## SITE INSTRUCTION

### SI #27

**PROJECT** : Forestside  
**PROJECT #** : 1331.15  
**DATE** : Apr. 4, 2023

**Title:** Revisions to plans as itemized.

SECOND FLOOR PLAN  
BUILDING C (PARTIAL PLAN)

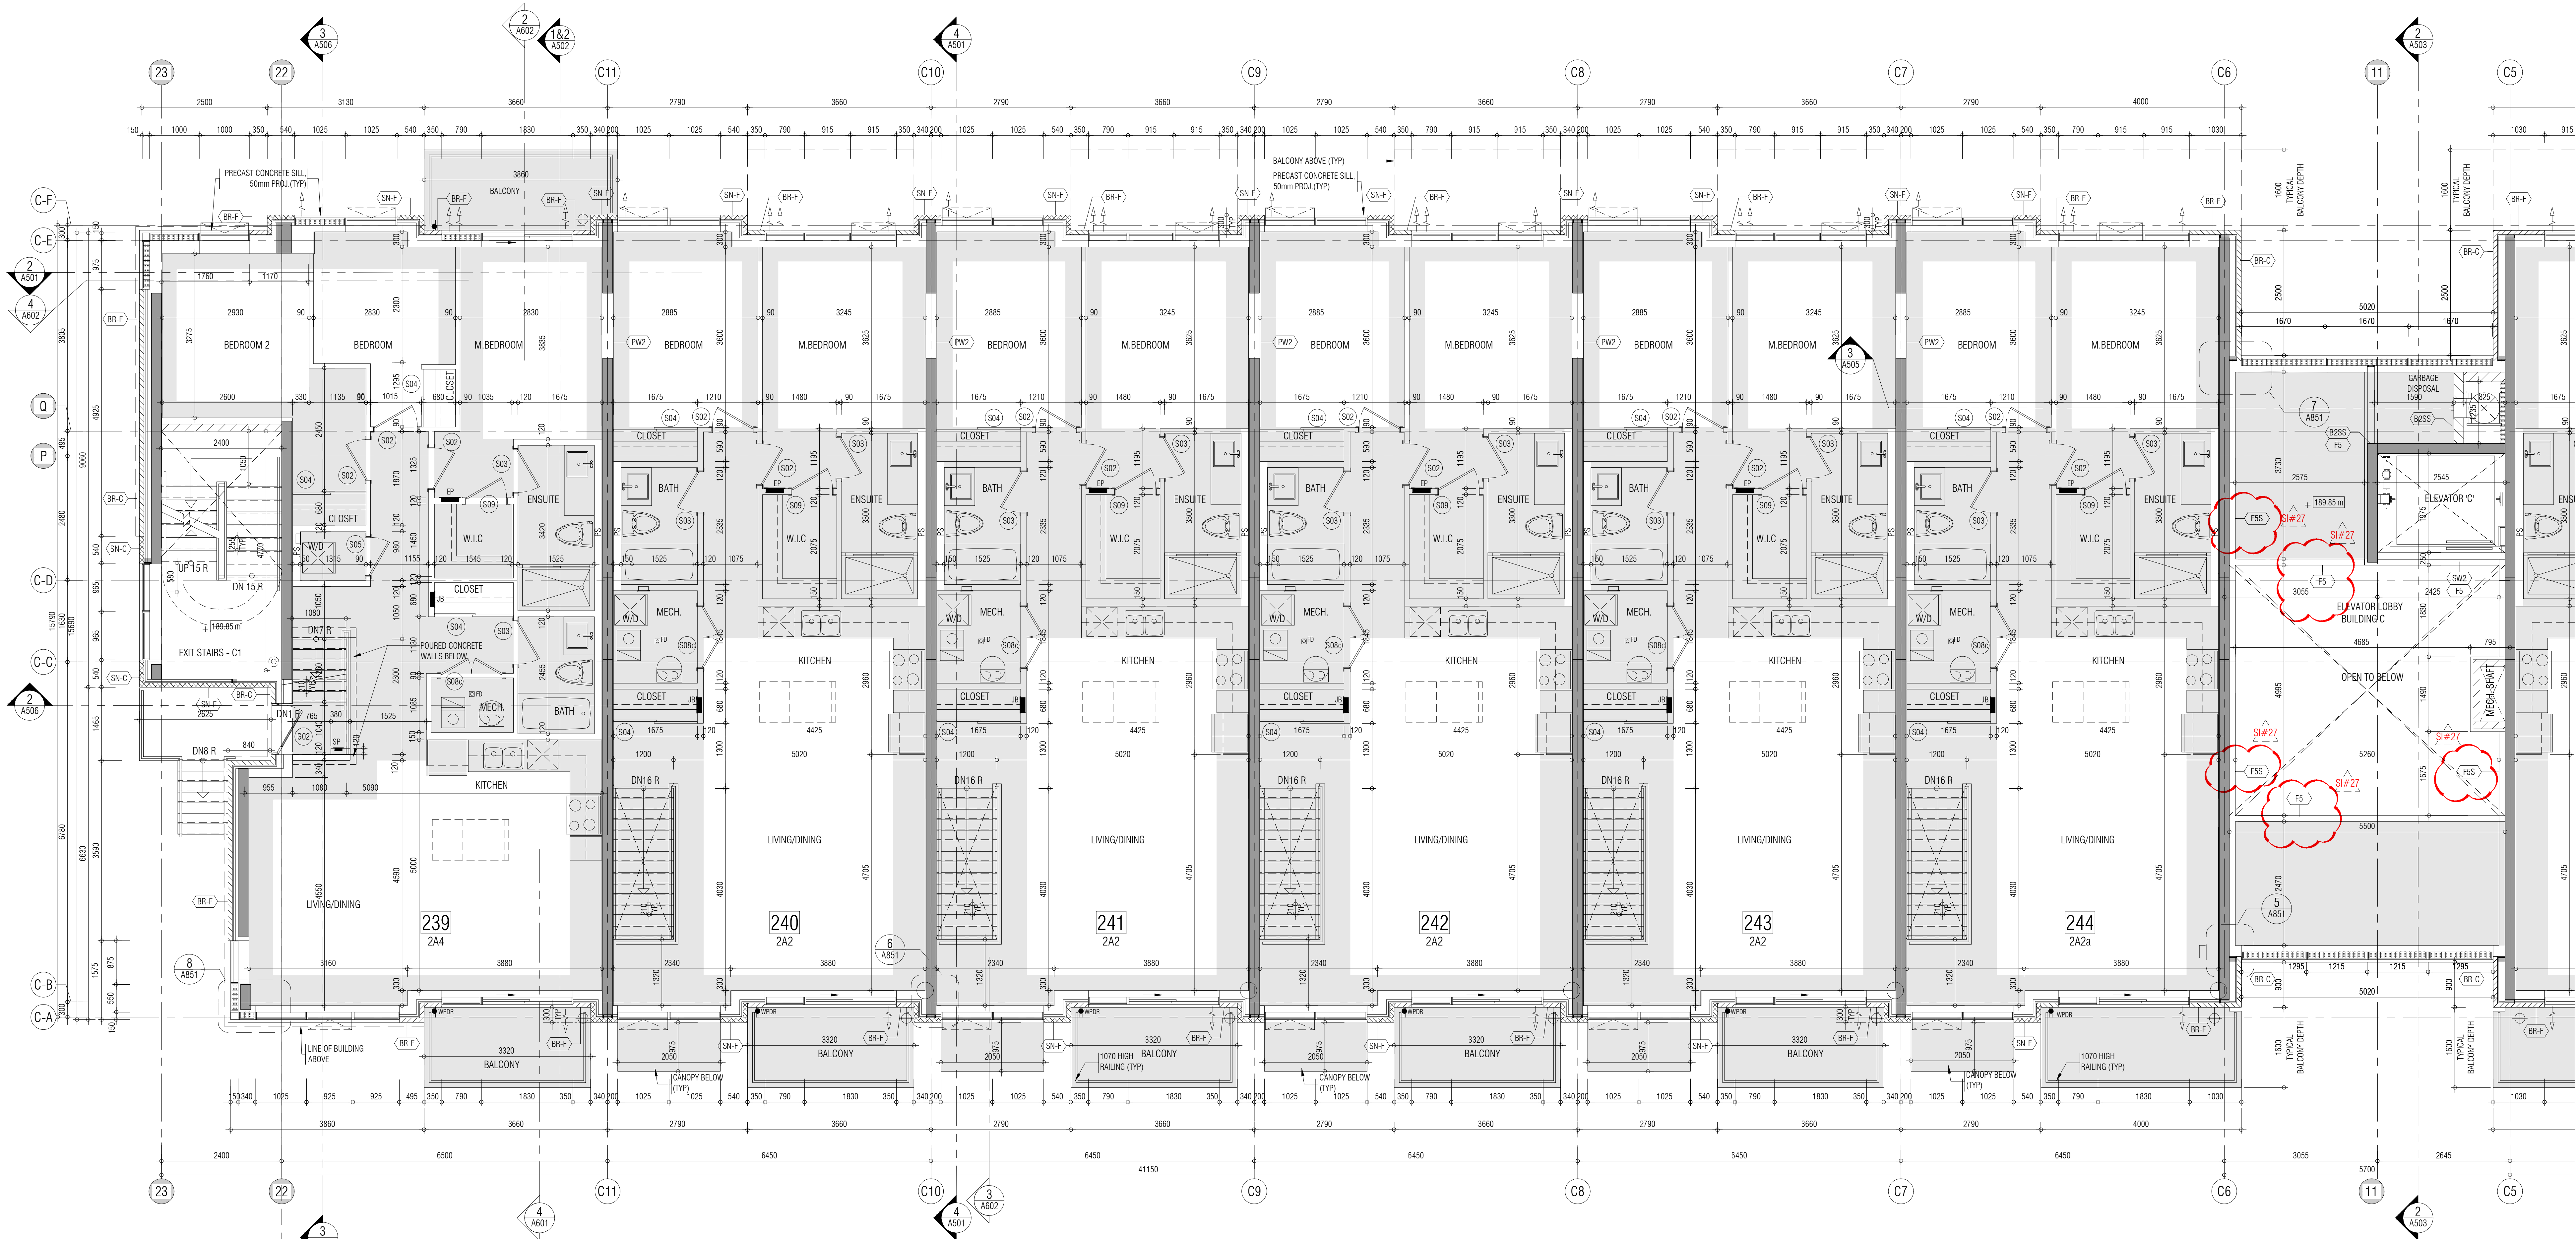
| Reference:    |                  | Changes:   |
|---------------|------------------|--|
| A302c1-A302c2 | 2nd Floor Plans  | <ul style="list-style-type: none"> <li>Revised wall tags at upper lobby from PW1B to F5 and F5S as noted.</li> </ul> |

**Reason:** Revisions to plans as per site comments and architectural review of approved wall types.

BUILDING SECTION

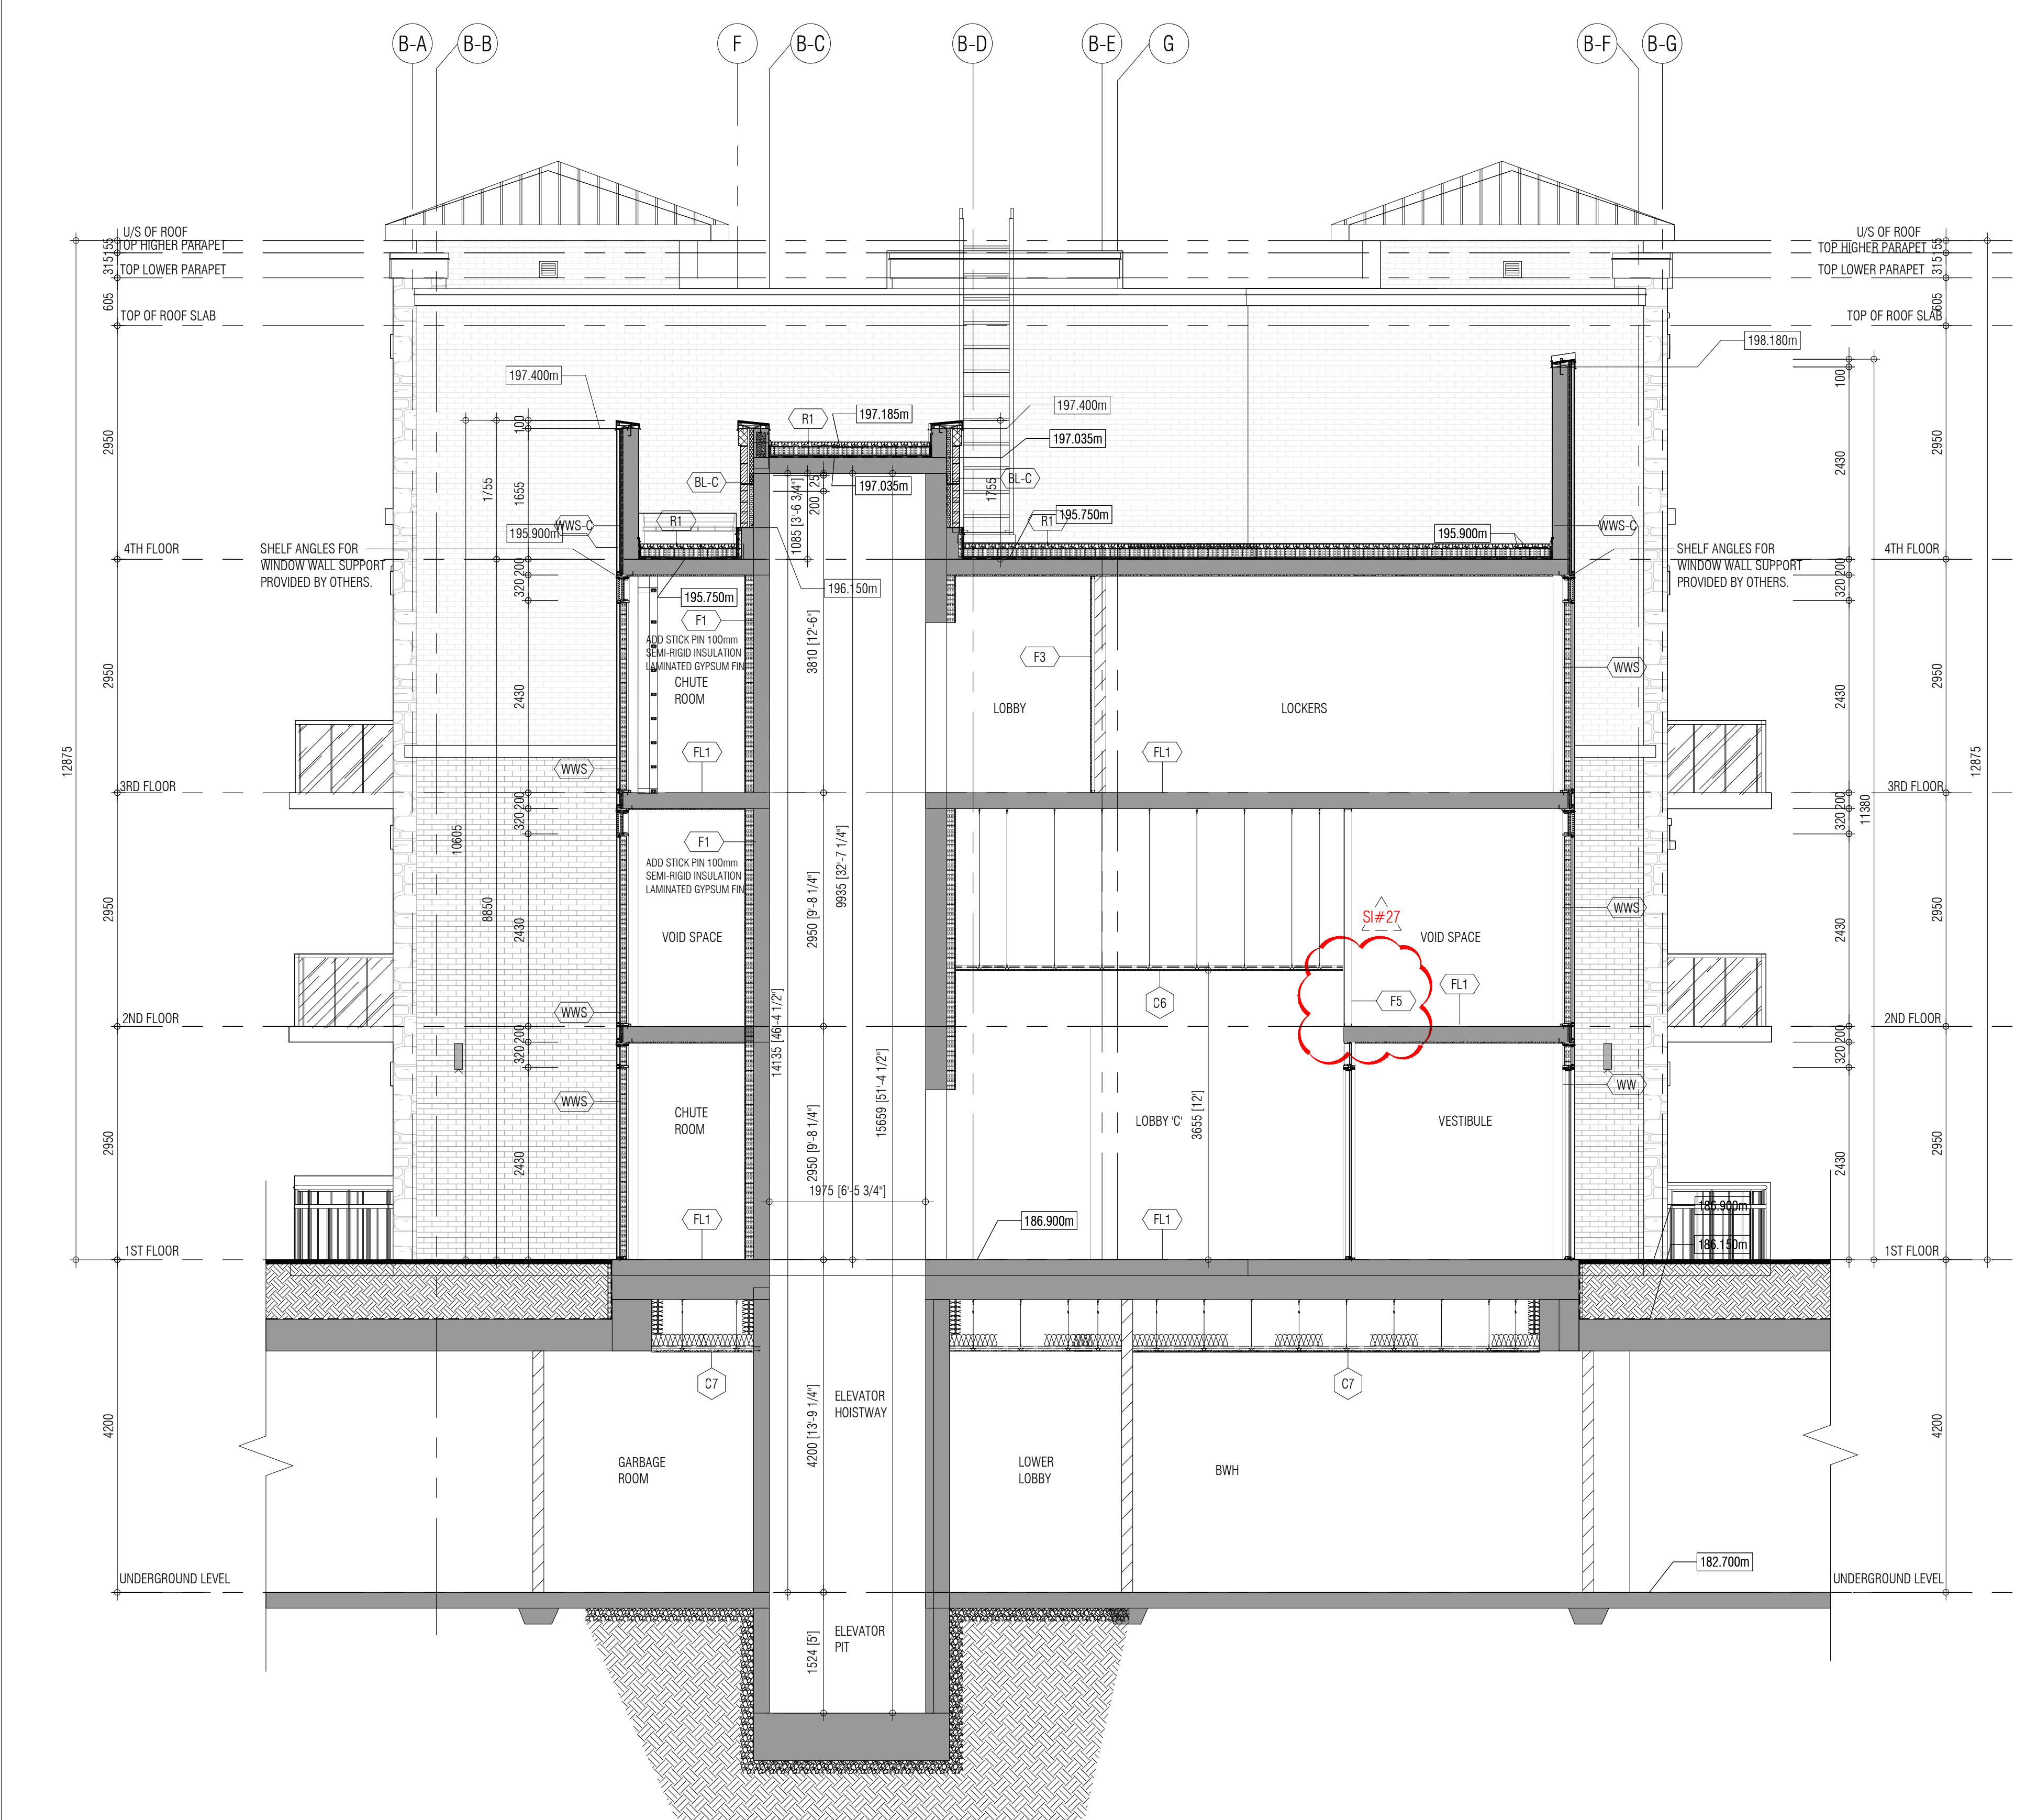
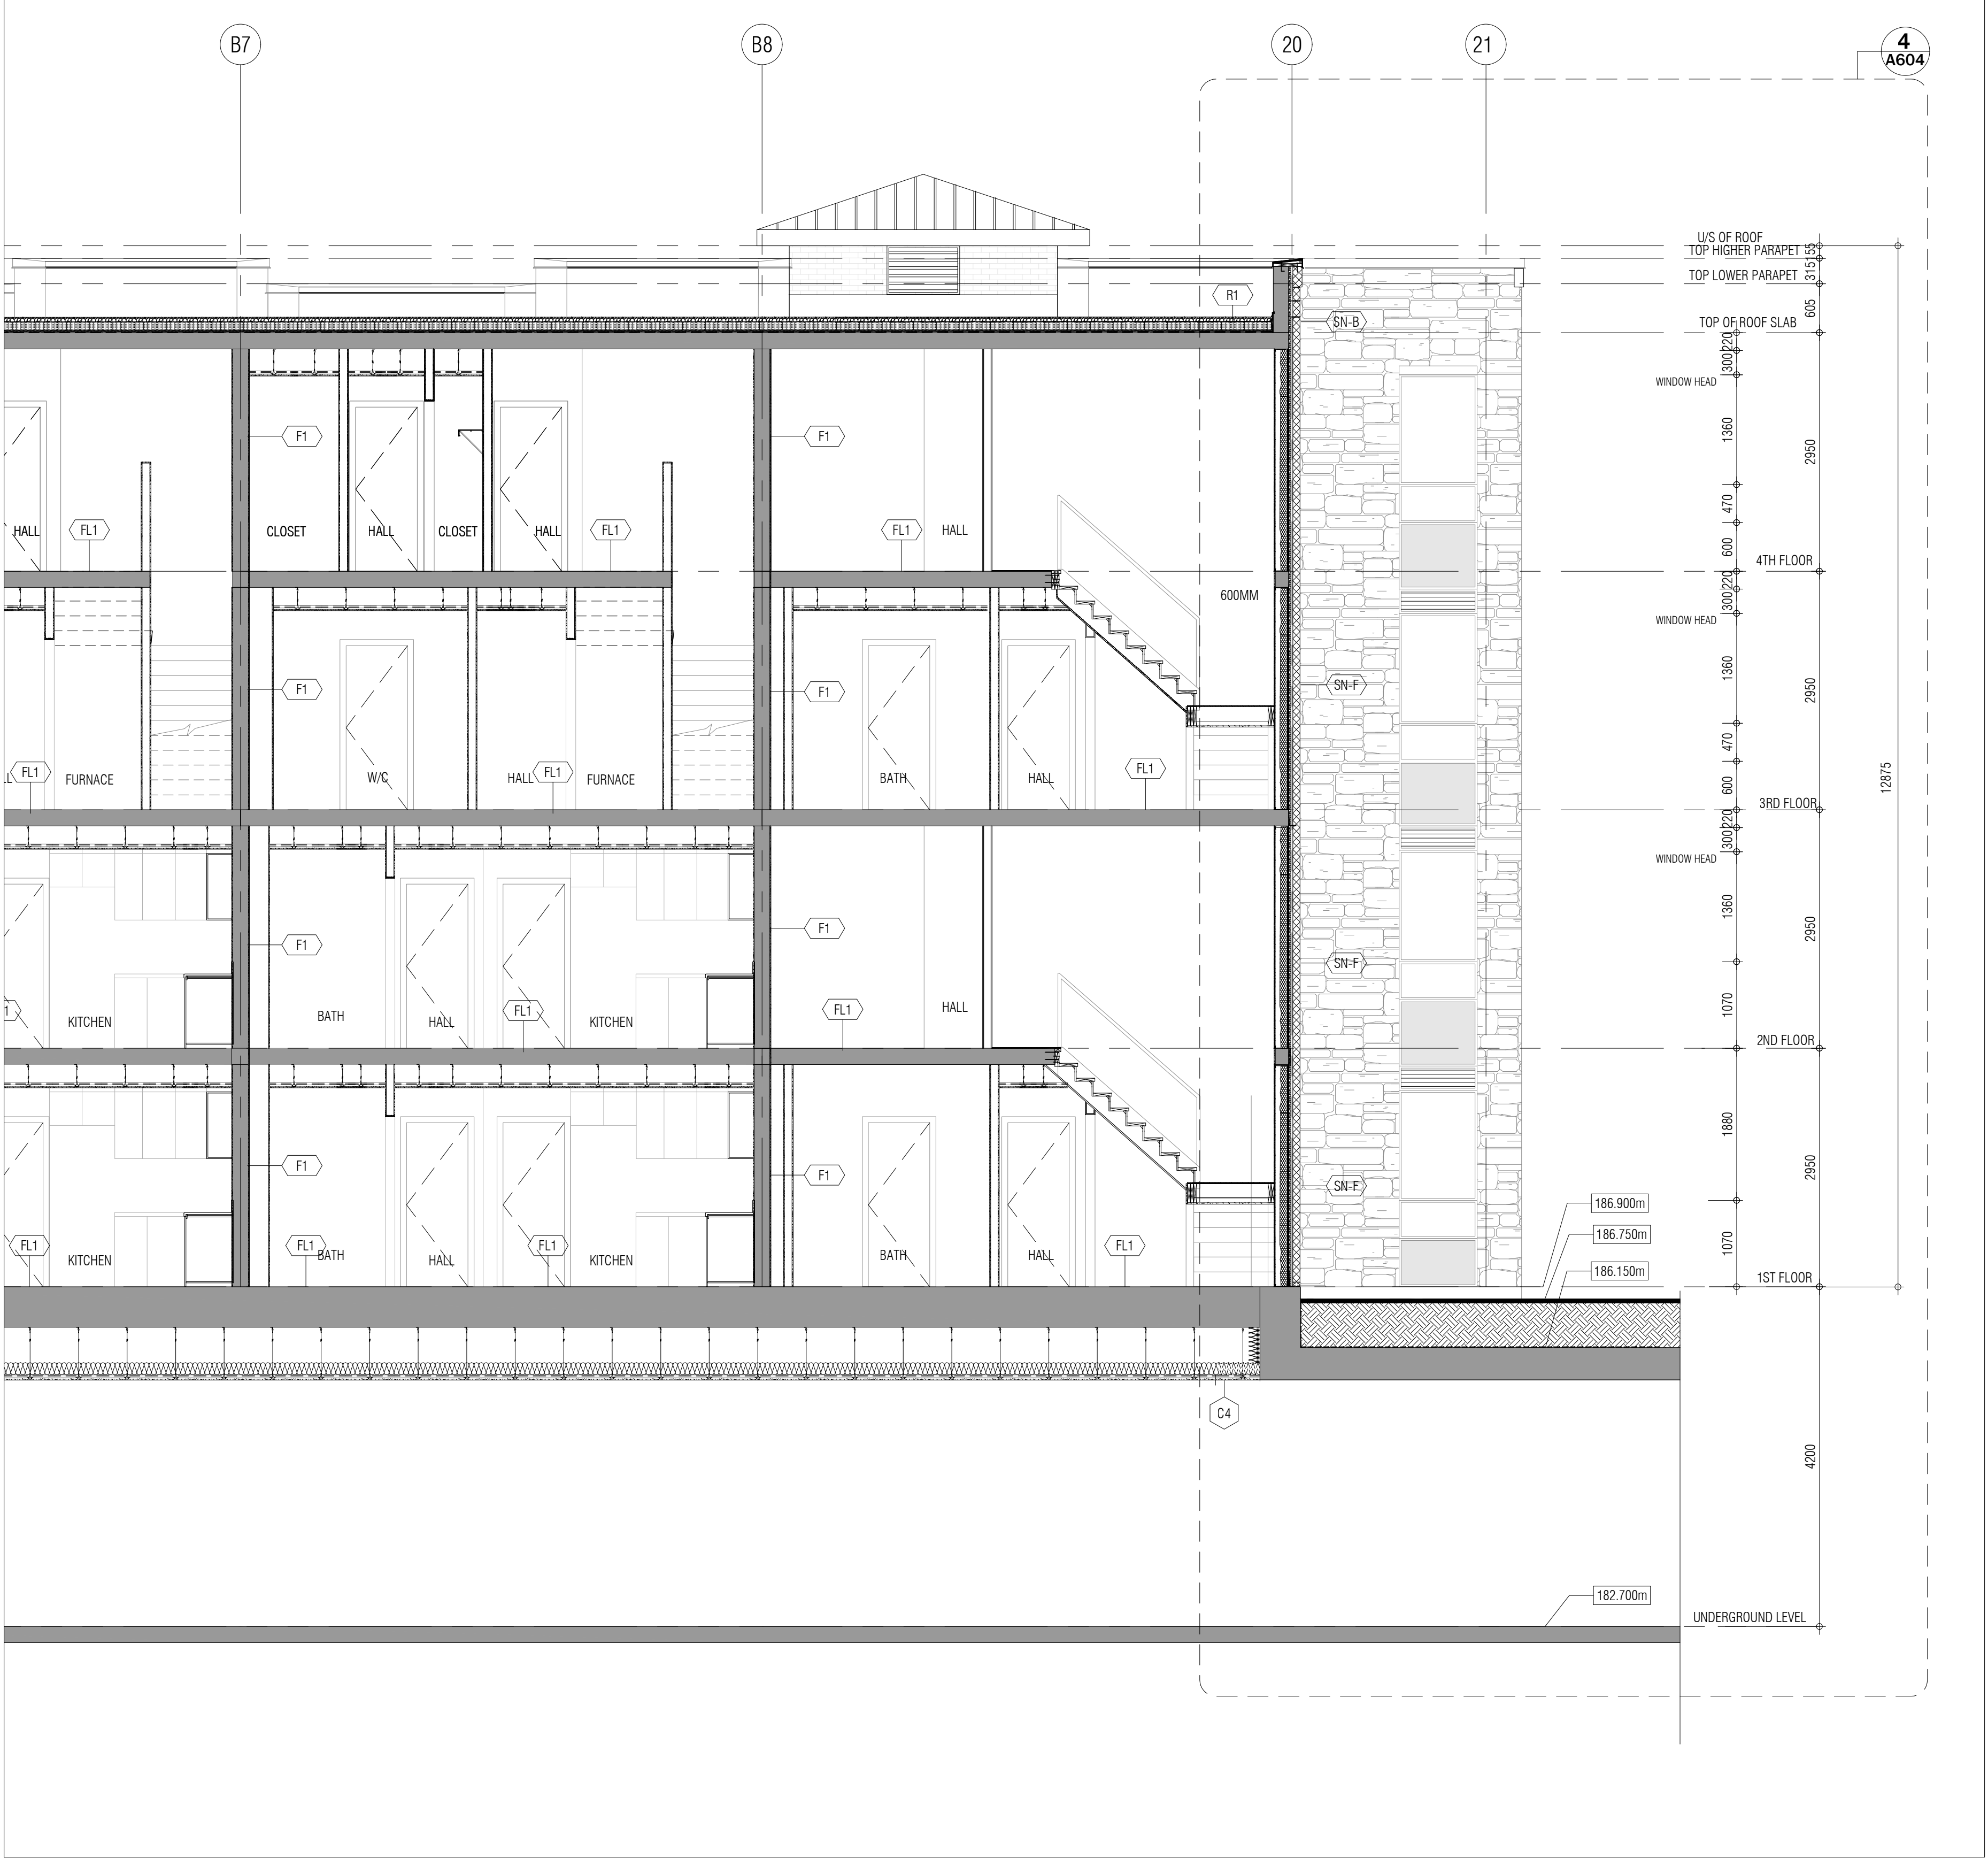
| Reference:    |                  | Changes:   |
|---------------|------------------|--|
| A503          | Building Section |  |
